# Memorandum

To: Charles Witherington-Perkins, Director of Planning and Community Development  
From: Sam Hubbard, Development Planner  
Date: 1/28/2022  
Re: Village Board Meeting on February 7, 2022 - PC #21-018: Southpoint PUD Amendment -  
Chipotle Outlot

SUBJECT: Traffic Signal Warrant Evaluation  
Palatine Road and Eastwood Drive/Southpoint Access Drive  
Arlington Heights, Illinois

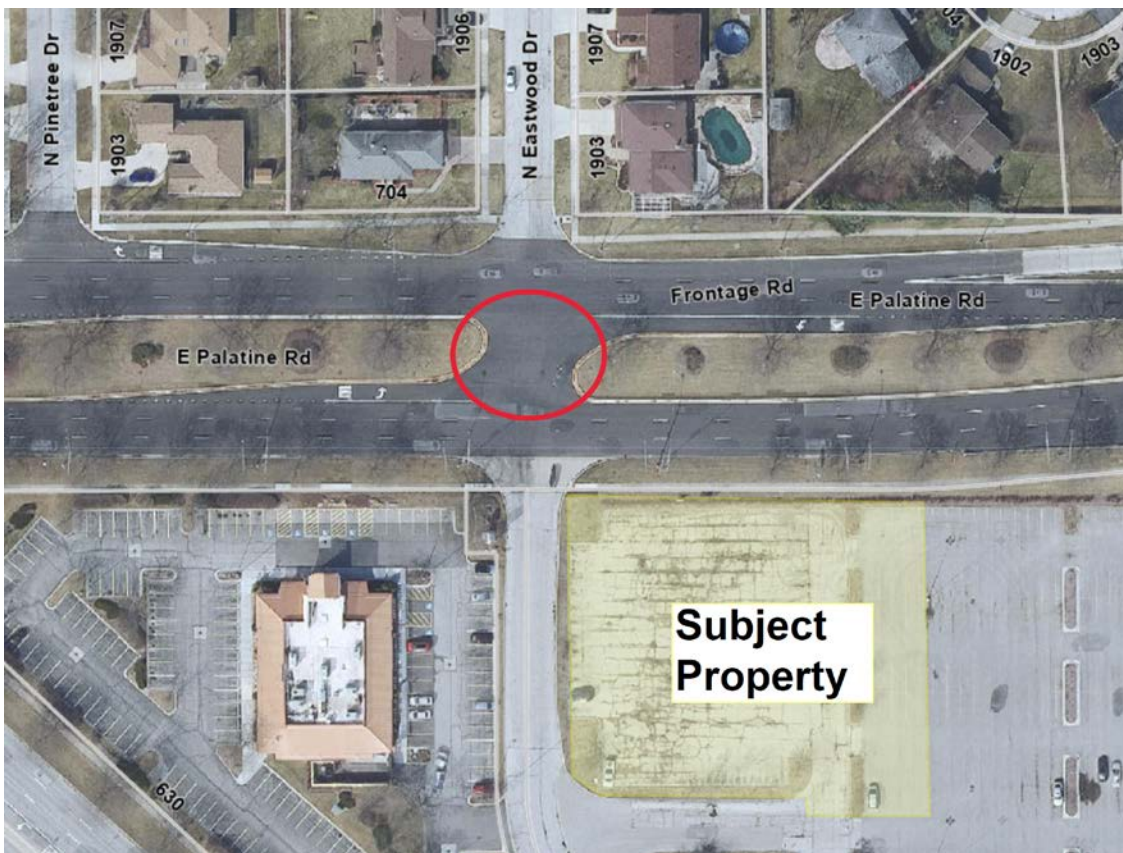
During review of application PC #21-018 (Southpoint PUD Amendment for the Chipotle Outlot), a resident reached out to the Village two days prior to the public hearing with concerns about the intersection of Palatine Road and the "Ring Road" access drive into Southpoint. This intersection provides non signalized full access via a "pass-through" (shown below in red):

Specifically, the resident was concerned with traffic safety at this intersection and inquired about possible improvements, such as a traffic signal, closure of the pass-through, and/or restrictions for no left turns. The specific concerns are outlined within the "Public Comments" document transmitted to the Village Board as part of this project.

In coordination with IDOT, an analysis of this intersection shows that it does not meet IDOT warrants for a traffic signal. Furthermore, review of historical crash data over the last five years shows that the frequency and severity of crashes in this location is not high compared to similar locations statewide. The expected traffic from the proposed development is not anticipated to have a significant impact on the existing functionality of the intersection. However, IDOT has agreed to install new yield and one-way signs in the median for both approaches to Palatine Road, which should help to improve traffic safety at the pass-through.

**Recommendation:** Based upon the above, it is recommended that the Village Board adopt the recommendation of the Plan Commission and approve the application subject to the conditions of approval as recommended by both the Plan Commission and the Staff Development Committee. No modifications to the plans or conditions of approval are recommended.
